#### V2500-A1/A5/D5 SERIES PROPULSION SYSTEMS SERVICE BULLETIN

This document transmits Revision 2 to Service Bulletin EV2500-70-0857 and Revision 2 to the Supplement

#### INFORMATION - ENGINE - PROVIDE IMPROVED PREFORMED PACKINGS

R FAMILY TREE - PREFORMED PACKINGS CATALOG SEQUENCE 72-32-20 FIG 01 ITEM 100, 72-32-25 FIG 02 ITEM 350 AND 72-32-53 FIG 01 ITEM 400.

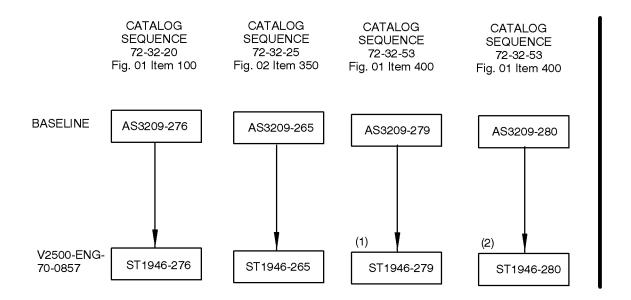
PART NUMBER CHANGE

- (1) For all A5/D5 Engines and for A1 engines incoporating SB 72-0132.
- (2) For A1 Engines only not incorporating SB 72-0132.

R FAMILY TREE - PREFORMED PACKINGS CATALOG SEQUENCE 72-42-30 FIG 01 ITEM 100, 72-58-02 FIG 01 ITEM 080.

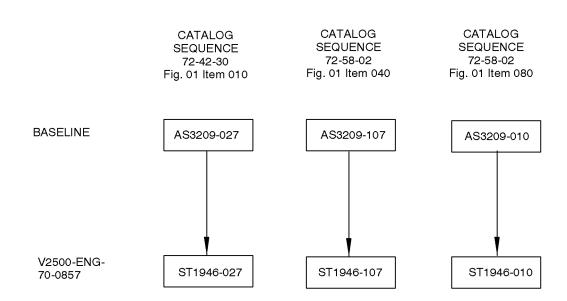
#### PART NUMBER CHANGE

FAMILY TREE - PREFORMED PACKINGS CATALOG SEQUENCE 73-11-41 FIG 01 ITEM 010 AND 73-11-41 FIG 02 ITEM 001.

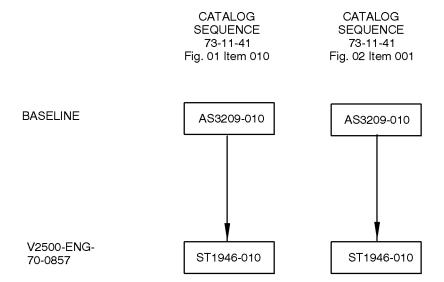
PART NUMBER CHANGE

FAMILY TREE - PREFORMED PACKINGS CATALOG SEQUENCE 73-11-41 FIG 03 ITEM 001 AND 79-21-49 FIG 16 ITEM 117.

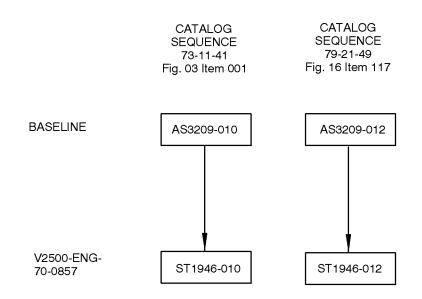
PART NUMBER CHANGE

FAMILY TREE - PREFORMED PACKINGS CATALOG SEQUENCE 73-50-53 FIG 20 ITEM 300 AND 72-50-53 FIG 20 ITEM 570.

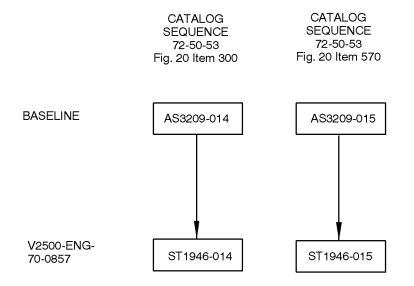
PART NUMBER CHANGE
